Subject: RESPONSE TO SECOND REQUEST FOR ADDITIONAL INFORMATION FOR REVISION 23 OF THE TRUPACT-II SHIPPING PACKAGE APPLICATION, DOCKET NO. 71-9218, TAC NO. L24643, AND REVISION 6 OF THE HalfPACT SHIPPING PACKAGE APPLICATION, DOCKET NO. 71-9279, TAC NO. L24642

ATTACHMENT A – Responses to RAI

Responses to NRC Second Round Request for Additional Information (RAI) on Revision 23 of the TRUPACT-II Safety Analysis Report (SAR), Revision 6 of the HalfPACT SAR, Revision 4 of the Contact-Handled Transuranic Waste Authorized Methods for Payload Control (CH-TRAMPAC), and Revision 3 of the CH-TRU Payload Appendices

Figure 1 – 55-gallon Drum Centered Source in HalfPACT
[^{60}Co allowable activity to meet 10 mrem/hr @ 2 meters = 0.139 Ci]

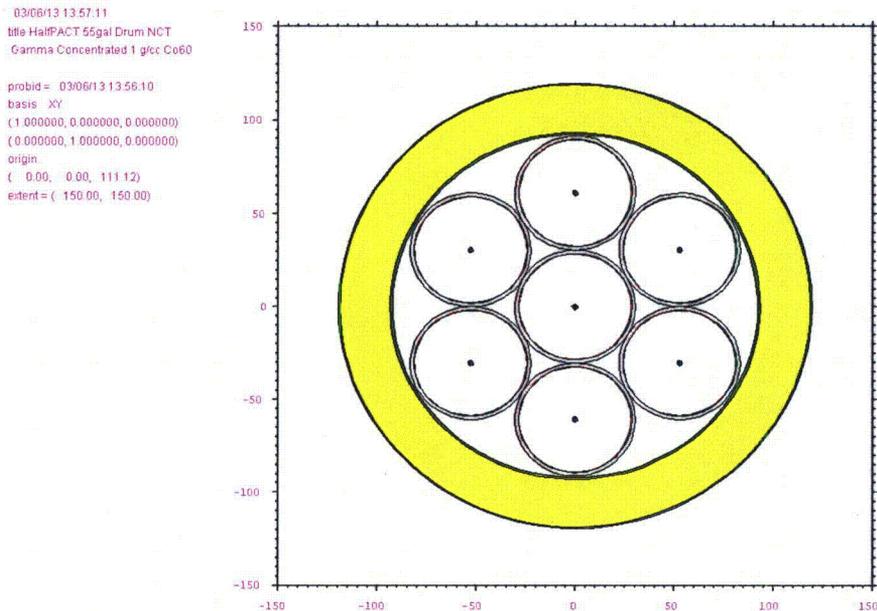
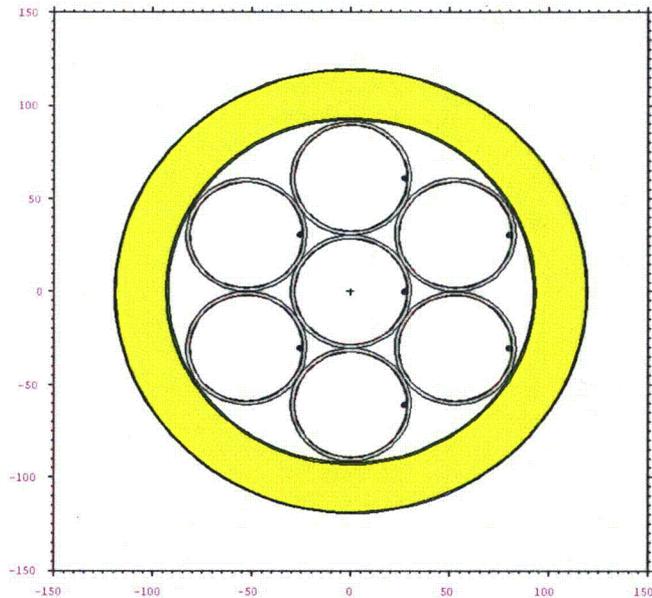
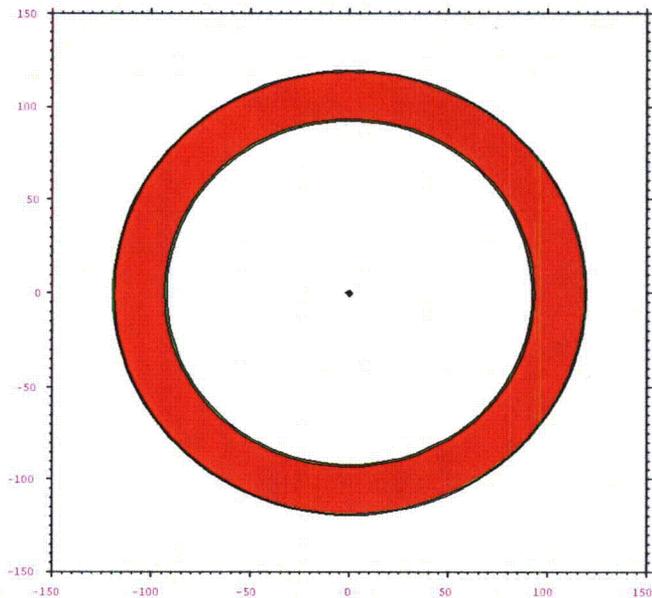
- 5.1 Provide an additional evaluation adequately analyzing the concentrated source in the most bounding location within the cavity consistent with normal conditions of transport (NCT) in order to identify the most limiting allowable activity.

As part of the previous RAI, staff requested that the applicant provide discussion to address the potential for a highly concentrated source being introduced into a payload/package near or at the container wall during NCT activities. From the applicant's response staff is aware that dose rate measurements are performed to determine the contributions from source material within the package. However, unless the applicant can demonstrate that any concentrated source could not relocate within the cavity under NCT, a bounding source configuration should be used that would produce the highest radiation levels for the surface and at 2 meters away. Moving the source closer to the cavity wall would result in higher surface and 2 meter dose rates.

The allowable content source term has been reduced to address the potential for reconfiguration of source material within payload containers under NCT. The revised limits require that the combined sum of the sum of fractions for the gamma and the neutron source terms be less than or equal to 0.9 in lieu of 1.0. As shown below, potential reconfiguration of the source material in the TRU waste payload containers under NCT is highly improbable and will not cause a significant change in the limiting package dose rate values.

^{60}Co sources that each moved the full distance to the inner surface of the drums, would increase by only $[(0.139/0.113) \times 100] - 100 = 23\%$ (see Figure 1 and Figure 2), as determined by the ratio of allowable activity determined through additional MCNP runs for each configuration to satisfy the limiting 2-meter dose rate of 10 mrem/hr. As such, the sensitivity of the payload container surface dose rate is exceedingly greater than the sensitivity of the package's limiting 2-meter dose rate to an equivalent amount of source movement. Further, the 0.113 Ci of allowable activity for seven 55-gallon drums containing fully offset sources is only $[(0.123/0.113) \times 100] - 100 = 9\%$ lower than that allowed by the Generic case analysis results presented in Section 5.1-2 of the TRUPACT-II SAR, which assume all activity is in a single centered source location (see Figure 3).

The occurrence of all drums having initially centered sources with full source reconfiguration to the worst location under NCT is not considered a credible scenario. However, even if it were assumed to occur, a very modest increase in the limiting 2-meter dose rate would result.

To address the highly improbable reconfiguration of source material within payload containers under NCT, Step 10 in Section 5.5.6 of the TRUPACT-II SAR and Section 3.3.2.1 of the CH-TRAMPAC have been revised to require that the combined sum of the sum of fractions for the gamma and the neutron source term be less than or equal to 0.9, in lieu of 1.0, effectively allowing a 10% administrative margin for the limiting 2-meter package dose rate.

Figure 4 – HalfPACT CCO Payload DCF (Evaluated up to 10 MeV)

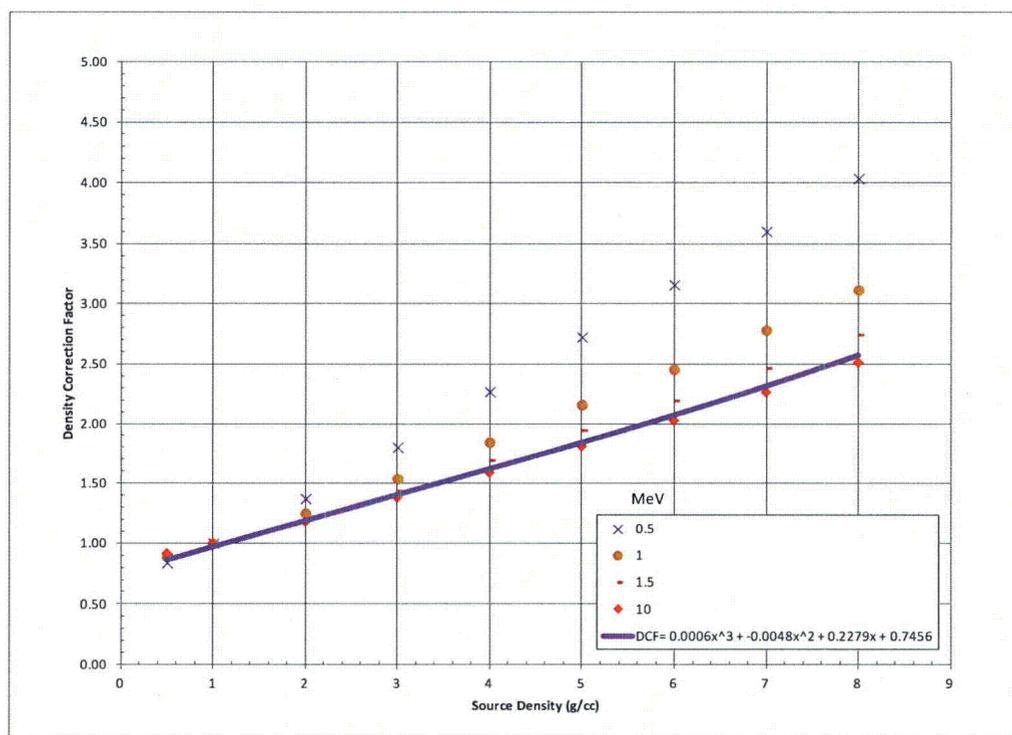
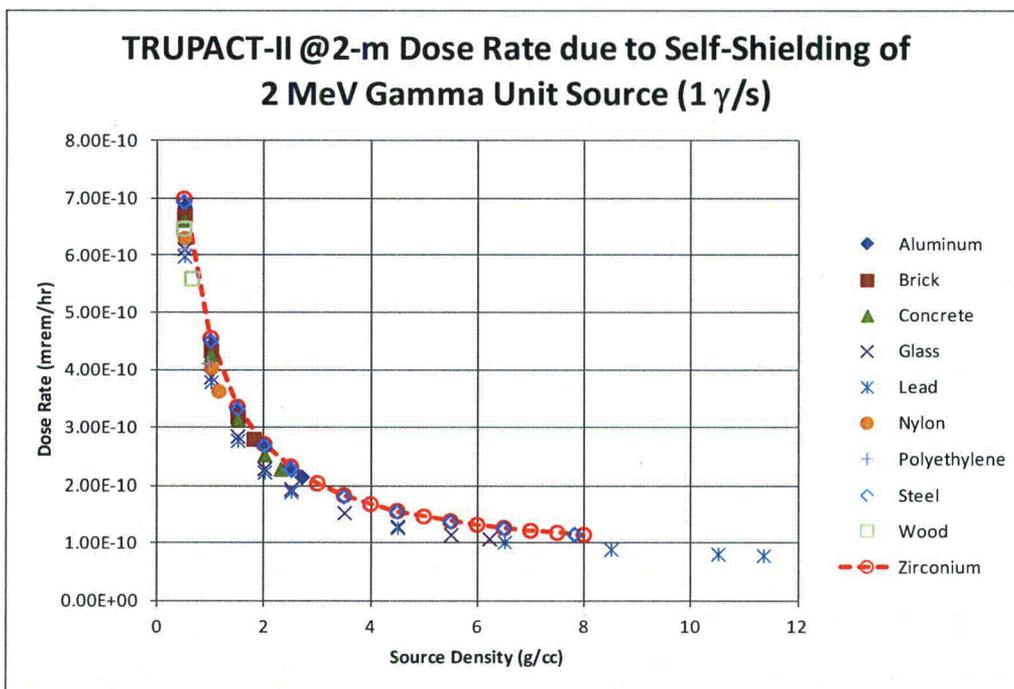
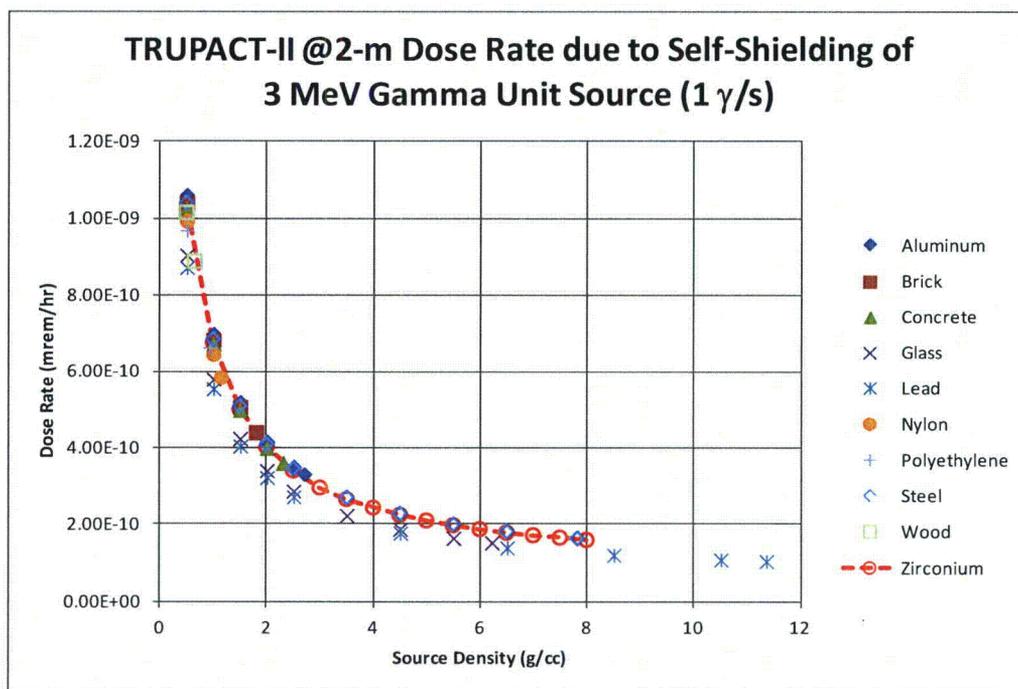
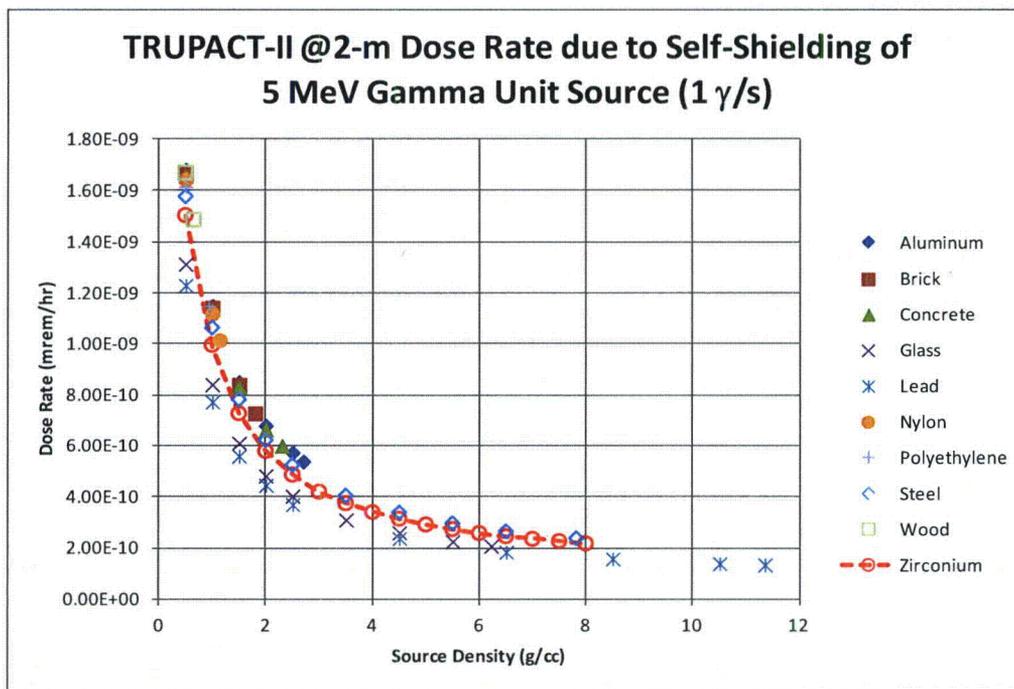
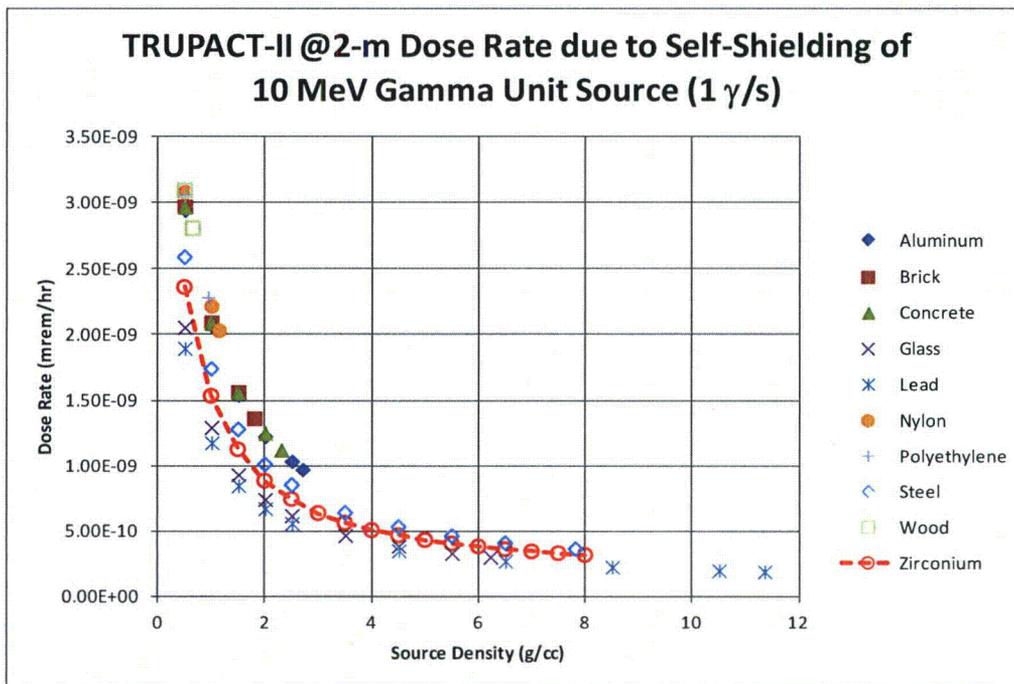
- 5.3 Provide adequate justification for the use of interpolation for DCF values for gamma energies from 2.0 MeV to 10 MeV, and justify the use of zirconium as the source material for use in the specified gamma energy range.

In the response to the initial RAI 5.5, the applicant stated that only a subset of cases were analyzed from 0.5 MeV up to 2.0 MeV in order to limit the number of distributed source shielding analyses. This data was then used and applied to gamma energies up to 10 MeV. As part of the responses, the applicant stated, in part, that the results between 1.5 MeV and 2.0 MeV were small and trending toward an asymptotic result as the gamma energy increased. However, the corresponding figures (Figure 5.5-5 and 5.5-6) in the SAR provided no data beyond 2.0 MeV. In addition, it is evident that different materials display different properties depending on energy levels. As such staff identified other materials in a separate reference ("Radiation Shielding" J. Kenneth Shultis and Richard E. Faw) such as carbon and beryllium that exhibited smaller mass interaction coefficients at the 5.0 MeV and 10.0 MeV ranges.

The use of zirconium-based 2 MeV DCF values for gamma energies ranging from 2 MeV to 10 MeV is appropriate because the 1.5 and 2 MeV values asymptotically approach a value that changes insignificantly with increasing energy. To further confirm that assertion, an additional case was run to evaluate the DCF for an upper energy level of 10 MeV for the CCO, per the methodology outlined in Section 5.5 and 5.5.2 of the TRUPACT-II SAR. The results are presented in Figure 4 for comparison with Figure 5.5-6 of the TRUPACT-II SAR. The 10 MeV zirconium results are essentially identical to the 2 MeV zirconium results utilized as the basis of the CCO DCF, demonstrating that the 2 MeV-based DCF determinations are appropriate to account for energies up to 10 MeV.

With regard to other materials that have lower mass attenuation coefficients, CHG-CAL-0002 was provided in the previous RAI response to demonstrate how zirconium compares with other common TRU waste materials from a self-shielding perspective. Those comparisons were provided for ^{137}Cs and ^{60}Co gamma sources and demonstrated that zirconium was well-behaved as a reasonable surrogate. Considering the conservative assumptions used to establish the distributed source limits and associated DCF methodology, particularly the use of the lowest single payload container density to establish the DCF for the entire payload, minor variations in attenuation properties for other non-dominant and/or obscure materials in TRU waste are not of concern. However, to demonstrate that the current methodology is robust, the CHG-CAL-0002 methodology was extended to include results for 2, 3, 5, and 10 MeV gamma energies, which are provided in Figure 5, Figure 6, Figure 7, and Figure 8 for the limiting 2-meter package dose rate location.

As shown in Figures 5 and 6, zirconium is bounding of other common TRU waste materials as it produces the largest dose rates for 2 and 3 MeV gamma sources. At 5 MeV, per Figure 7, zirconium is within 10% of the least effective common TRU waste materials from a self-shielding perspective. Although, per Figure 8, the deviation

between zirconium and nylon and wood is more pronounced (~30%), the theoretical densities of these materials are so low that dominant quantities would limit the source density to less than 2 g/cc and correspondingly limit the DCF to a small (<1.5) correction factor. Of further significance, the current CH-TRU waste inventory of known radionuclides listed in Table 3.1-2 of the CH-TRAMPAC contains no radionuclides that have gamma energies in excess of 3 MeV, and there are no known radionuclides (per PCNUDAT) with gamma energies in excess of 5 MeV that have half-lives greater than 7 days.

Therefore, the use of zirconium as a surrogate self-shielding material for TRU waste is appropriate, bounding up to 3 MeV, within 10% of the least effective common TRU waste material up to 5 MeV, and irrelevant to gamma energies beyond 5 MeV due to the extremely short half-lives of radionuclides that produce those gamma energies.

To address the unlikely condition of the dose rate of distributed source material being dominated by high energy gammas and/or the self-attenuation of light elements that are less effective than zirconium, Step 10 in Section 5.5.6 of the TRUPACT-II SAR and Section 3.3.2.1 of the CH-TRAMPAC have been revised (consistent with the RAI 5.1 response) to require that the combined sum of the sum of fractions for the gamma and the neutron source term is less than or equal to 0.9, in lieu of 1.0, effectively allowing a 10% administrative margin for the limiting 2-meter package dose rate.
